**REVIEW OF THE WATER USE LICENSING APPLICATION for a RESIDENTIAL DEVELOPMENT IN  
KEURBOOMSTRAND, PLETTENBERG BAY. Dated September 2024**

**Dr D A Hughes, PrSciNat  
Emeritus Professor  
Rhodes University  
Grahamstown / Makanda**

**Date of Review: 5 November 2024**

Figure 2 Cross-section through part of the proposed development site (south is on the left, north on the right).

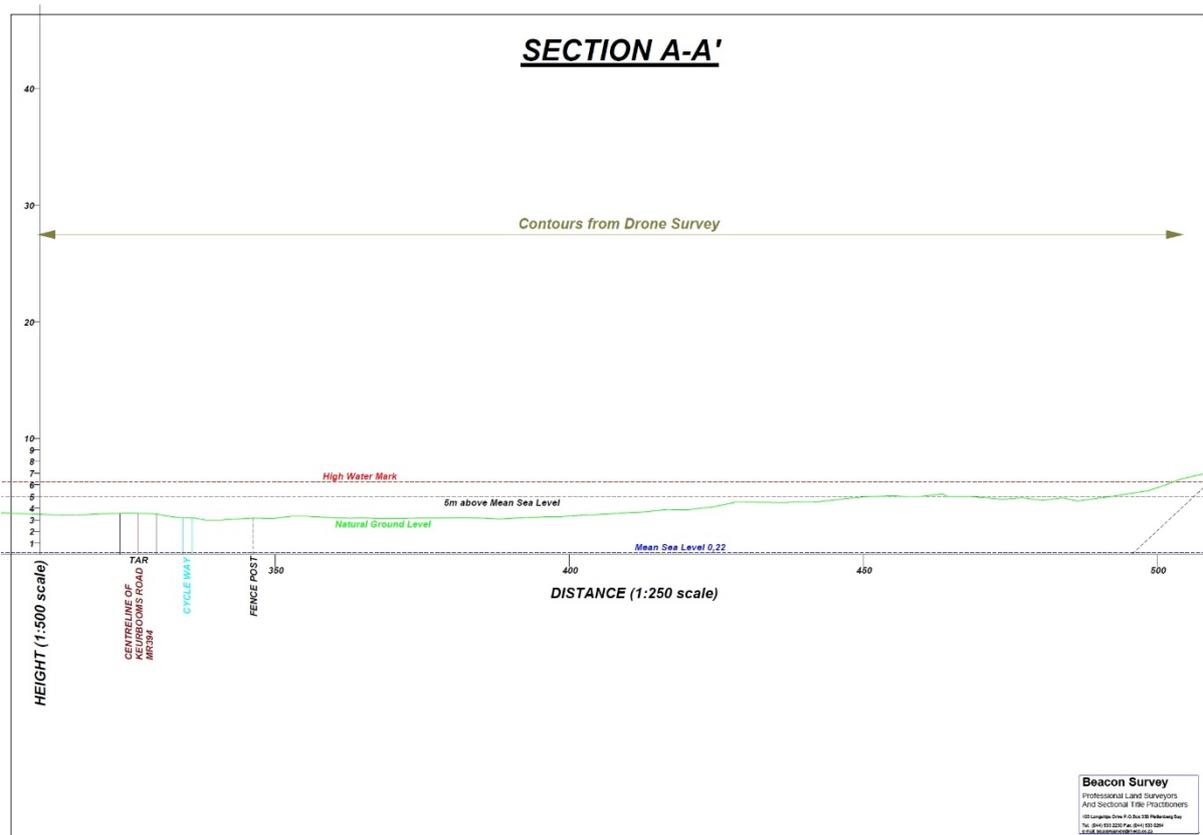
The cross-section data suggests that almost all parts of the development will be below 5m above mean sea level (the black dashed line in Figure 2). There seems to be little doubt that the site does play a role in providing some flood storage, as well as the fact that the site is highly likely to be flooded during heavy and prolonged rainfall events.
